SOLACE AT CIMARRON HILLS
— FILING NO. 1
SITE AND OVERALL UTILITY PLAN

SOLACE AT CIMARRON HILLS

SITUATED IN THE NORTHWEST QUARTER OF SECTION 7
TOWNSHIP 14 SOUTH, RANGE 65 WEST OF THE SIXTH PRINCIPAL MERIDIAN
COUNTY OF EL PASO, STATE OF COLORADO
SANITARY SEWER PLAN AND PROFILE

WATER DISTRIBUTION PLAN

SOLACE AT CIMARRON HILLS
WATER DISTRIBUTION PLAN
SHEET 6 OF 10
JOB NO. 25174.00

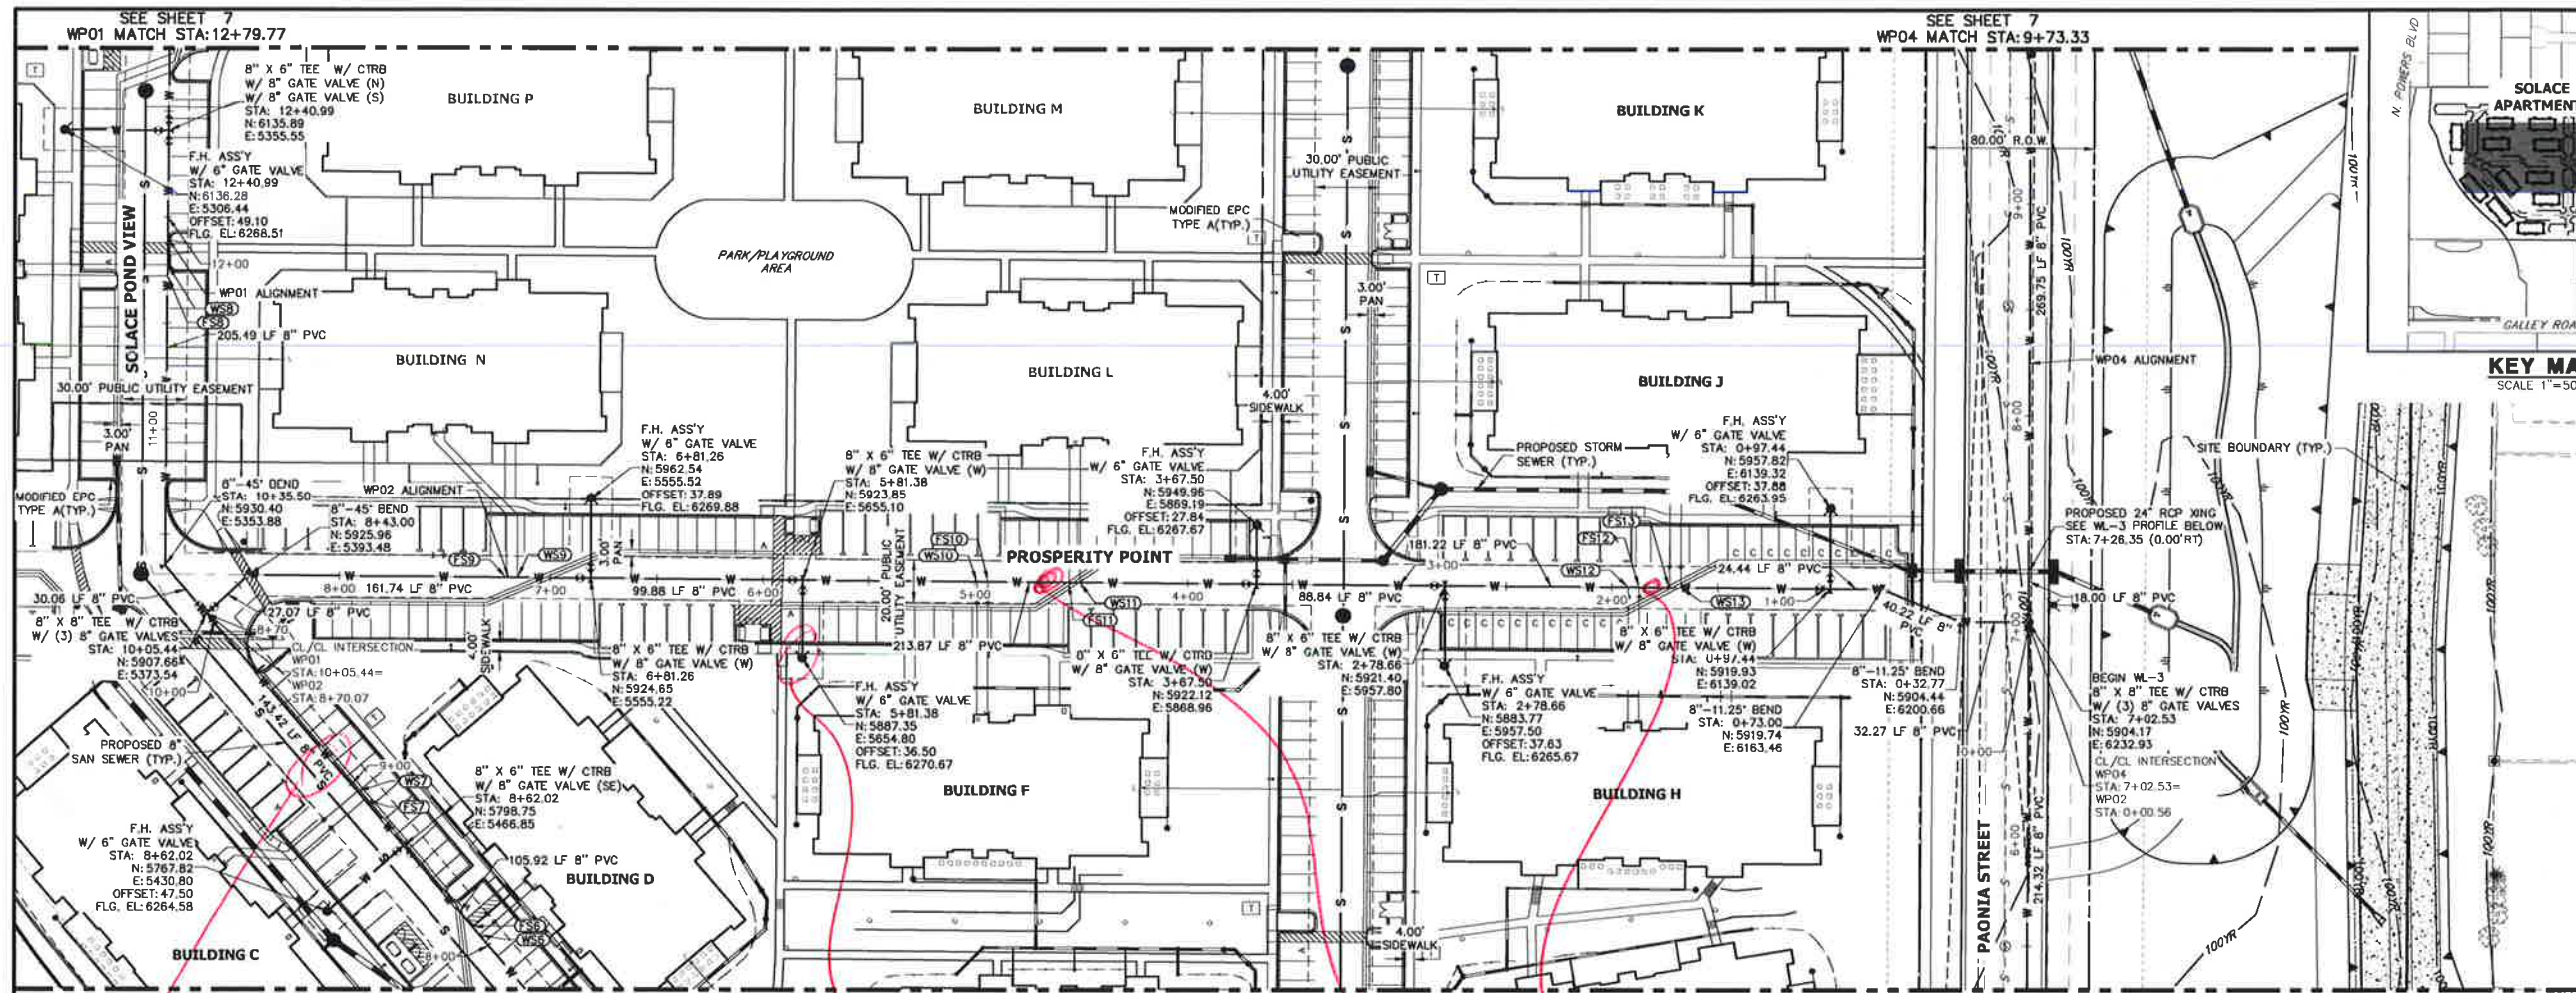
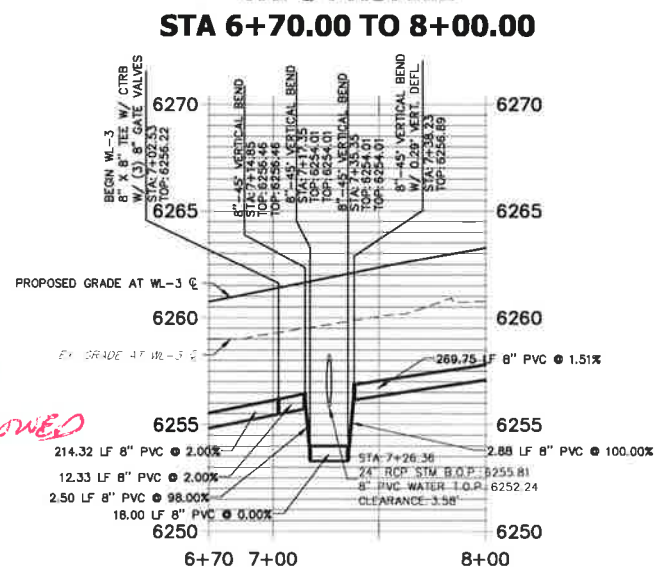
ADD SIZE & MATERIAL OR USE GENERAL NOTE

CONFIRM W/ FIRE DEPT THAT HYDRANT CAN BE BEHIND PARKING SPACE (TYP) WL-3 PROFILE

SHOW VALVES ADDED TO MATCH SHEET 4 OF 28 "SITE DEV. PLAN"

LABEL 30' PUBLIC UTILITY EASEMENT "NO COVERED PARKING FOUNDATIONS ALLOWED IN EASEMENT"

SHEET 8 OF 10

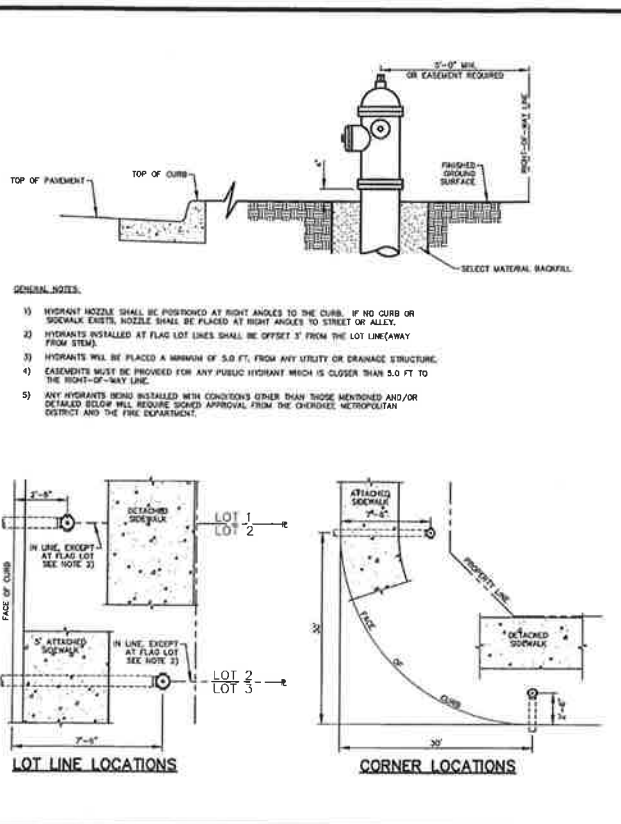
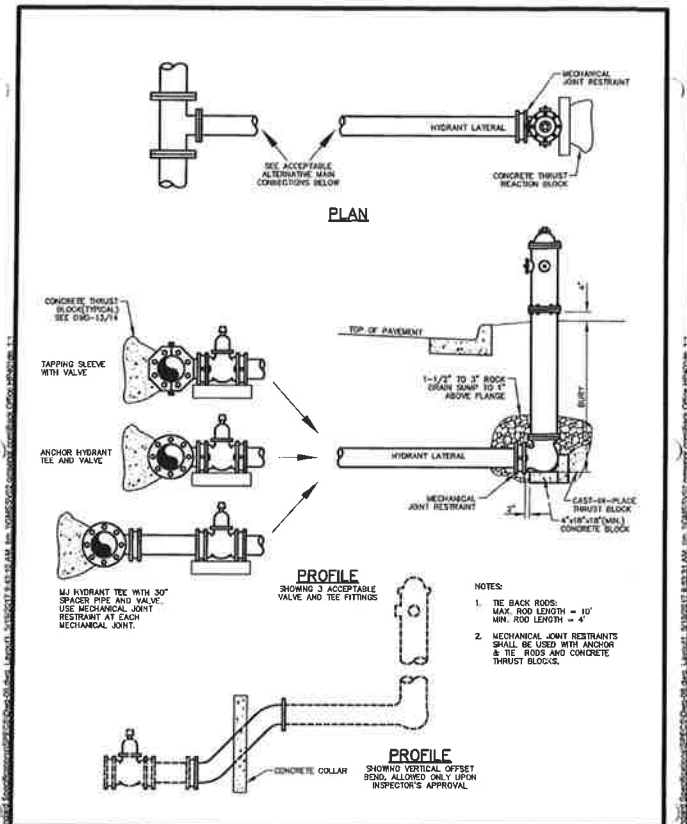
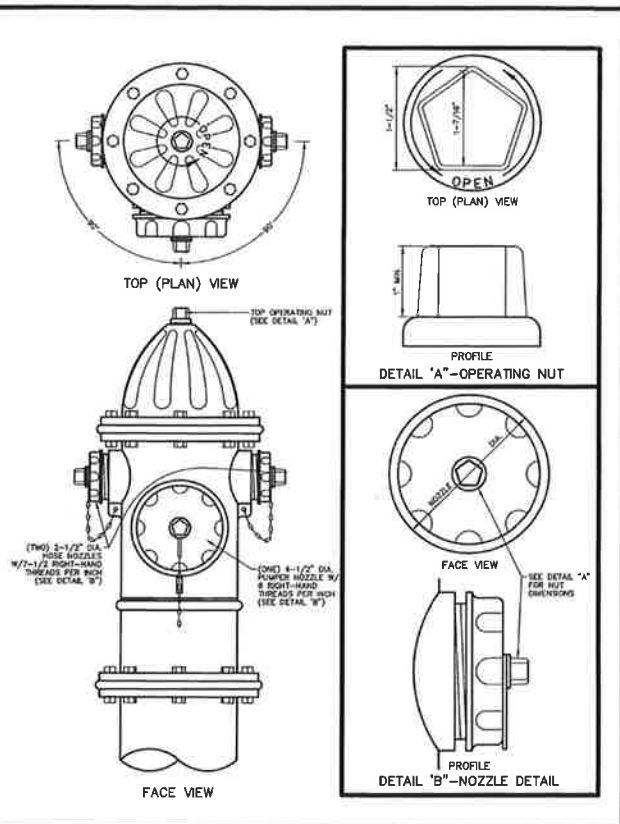
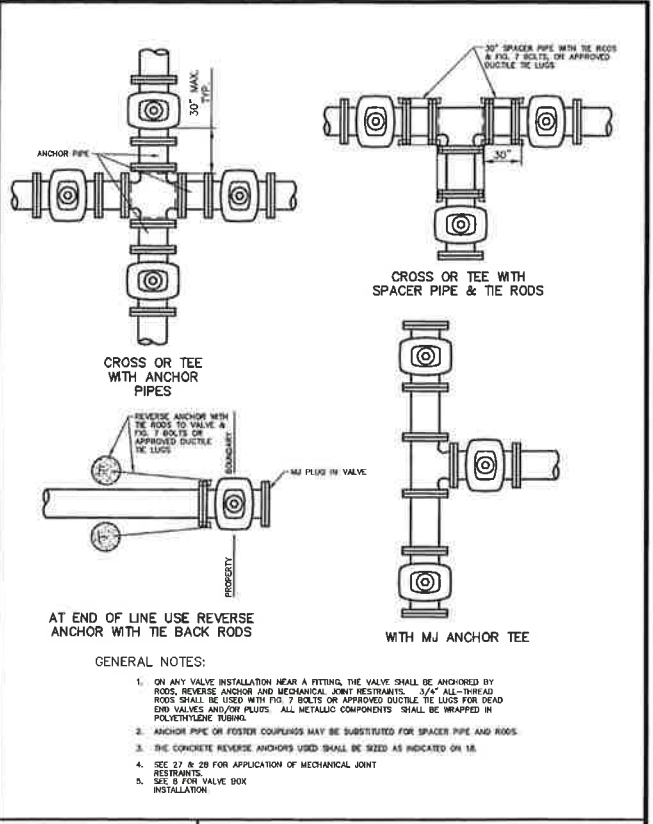
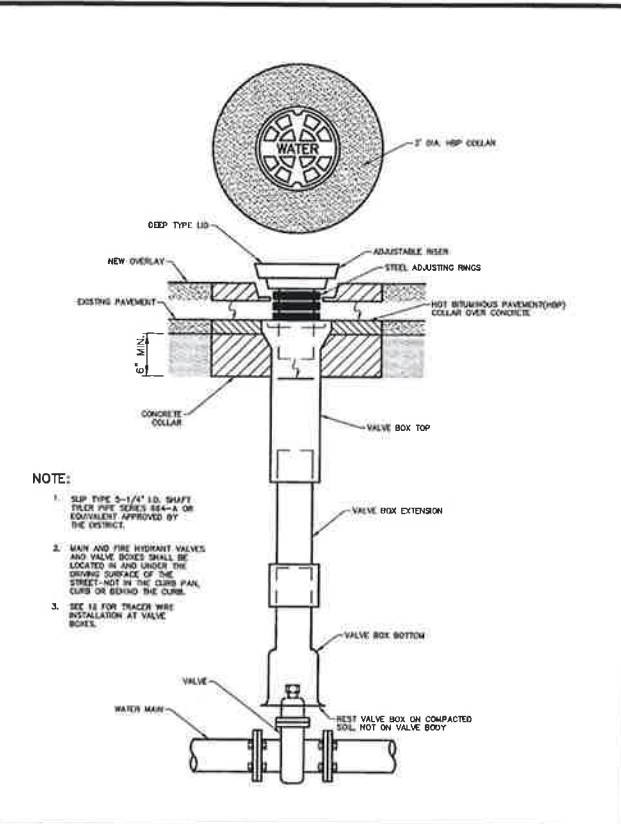
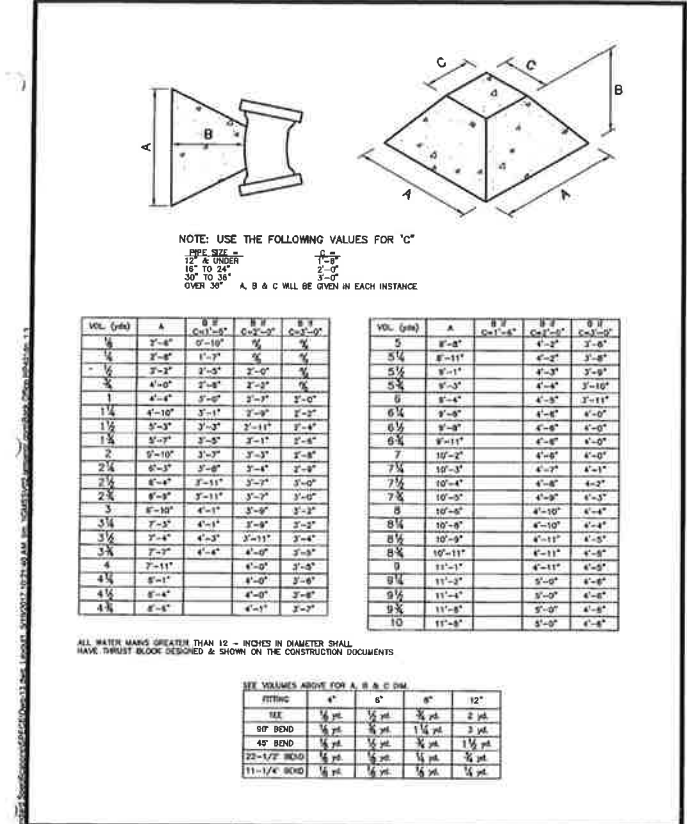
REPLACE w/ CSU STD

SHEET 9 OF 10
JOB NO 25174.00

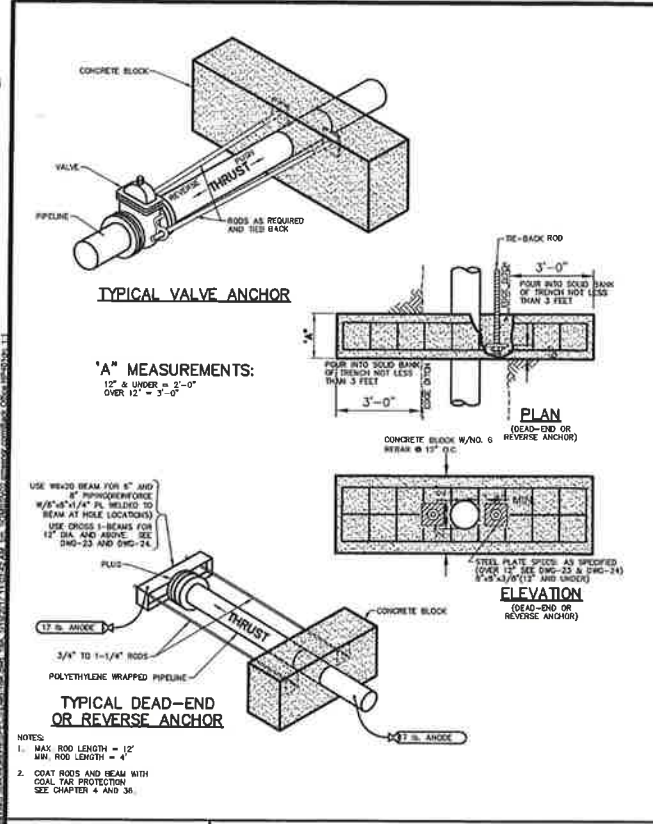
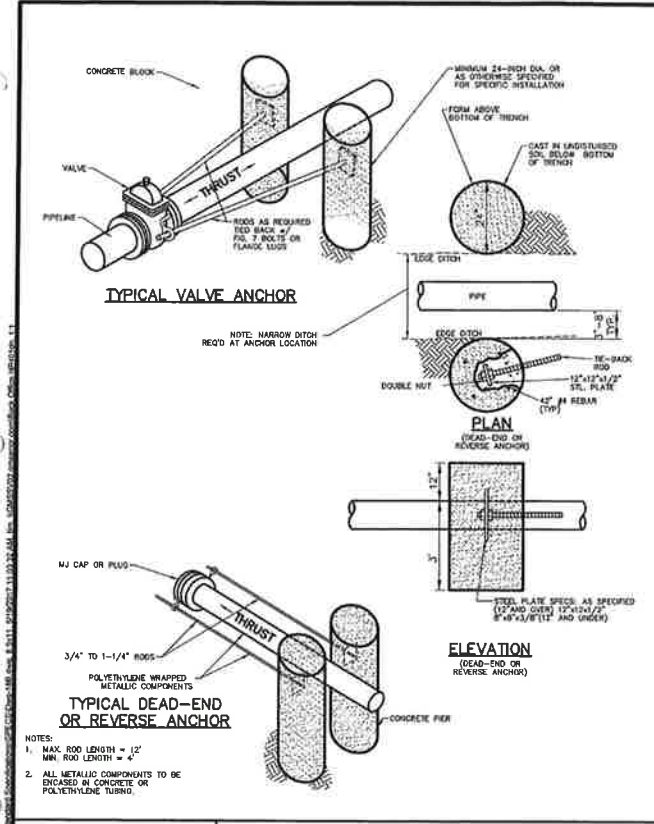
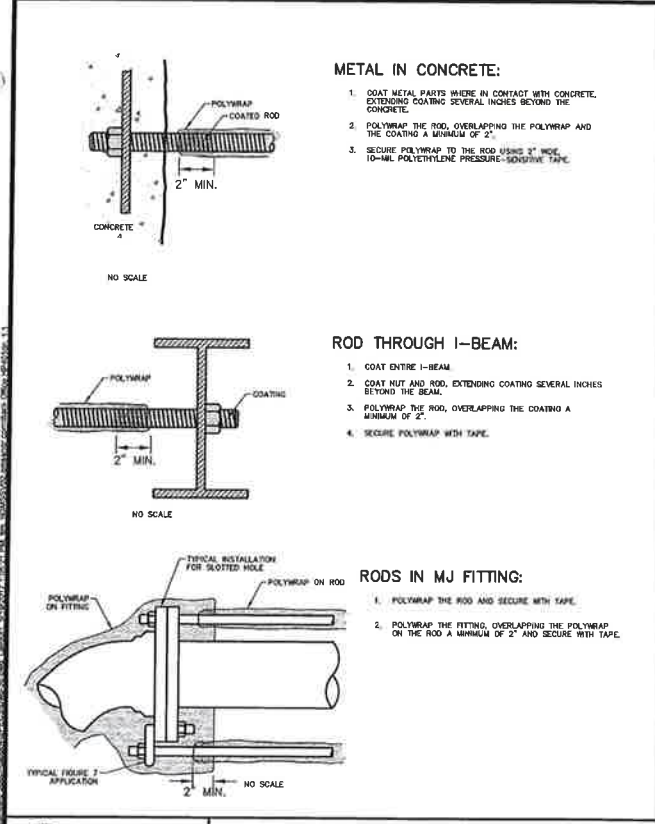
REPLACE w/CSU
STDS
